3-B-21-HZ
APPLICATION FOR CERTIFICATE OF APPROPRIATENESS

2328 Jefferson Ave. 37917
Edgewood-Park City H

Original Print Date: 3/9/2021
 Knoxville/Knox County Planning -- Historic Zoning Commission

Porch railing baluster design taken directly from Sears Roebuck Home Builder's Catalog, 1910 edition.

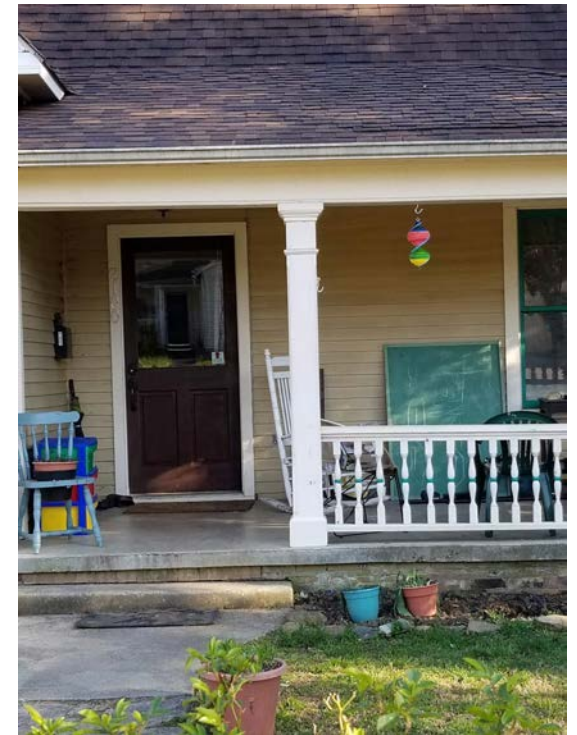
6. A unique element included in the application is a flat sawn balustrade, shown in a c.1910 Sears Roebuck catalogue provided by the applicant. There are not historic photographs showing the balustrade on the original house. The catalogue does date to the house's approximate period of construction, and other examples of this railing do exist in historic districts in Knoxville, especially on slightly larger/more high-style houses in Fourth and Gill and Edgewood-Park City.

7. Building code requires a railing to be 36" tall minimum when the foundation height is 30" tall or over. The specs included in the Sears Roebuck catalogue describe the individual balusters at 20" or 24" tall. The applicant could modify the design of the balusters, install a double rail at the top to make up the difference, or select a more simple square picket design; the Commission should discuss these options.

Staff recommends approval of the work as proposed, with the following conditions: 1) final window specifications and placement to be submitted to staff for approval; 2) proposed balusters to meet building code, with final selection submitted to staff for approval.

Supporting Information

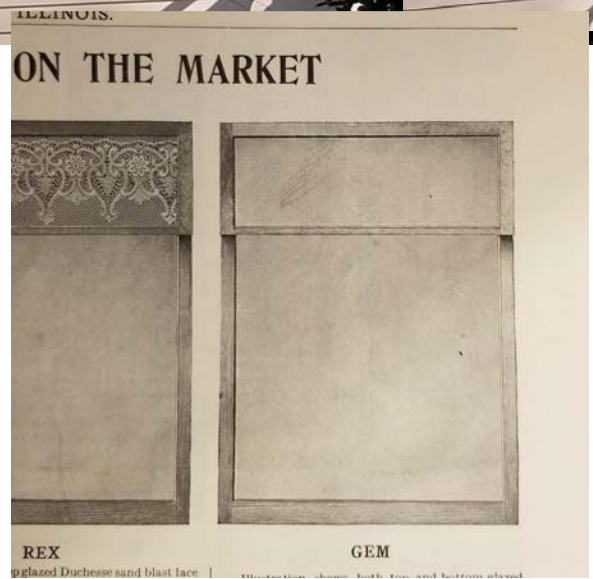
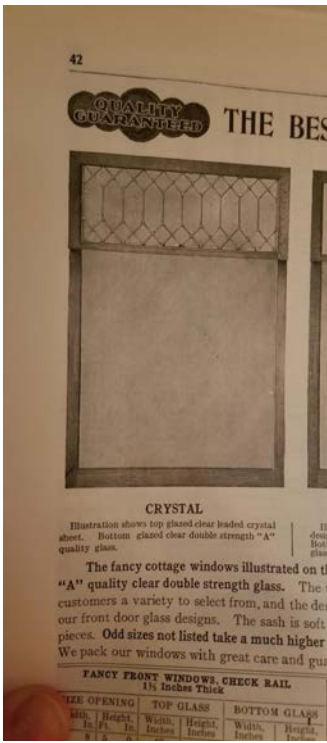
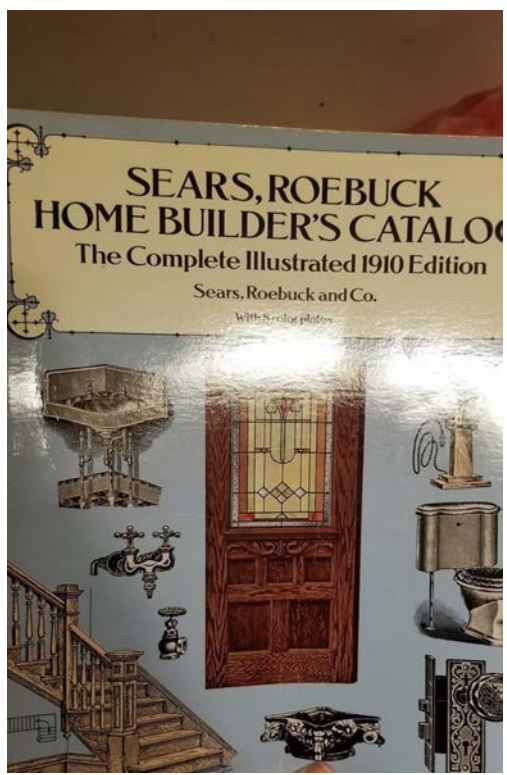
3. The replacement of one-over-one, double-hung wood windows with wood trim meets the design guidelines. The proposed replacement window on the front porch matches a similar window on an adjacent property and a Sears Roebuck catalogue from 1910. If the applicant is unable to find a window in the submitted design, a 1/1 double-hung wood window would also be appropriate.

5. The porch work also includes the removal of non-historic wrought iron columns and railing and installation of wood materials. The dimensions and design of the proposed square wood columns with simple trim at the top and bottom will reflect those on an adjacent, comparable house.
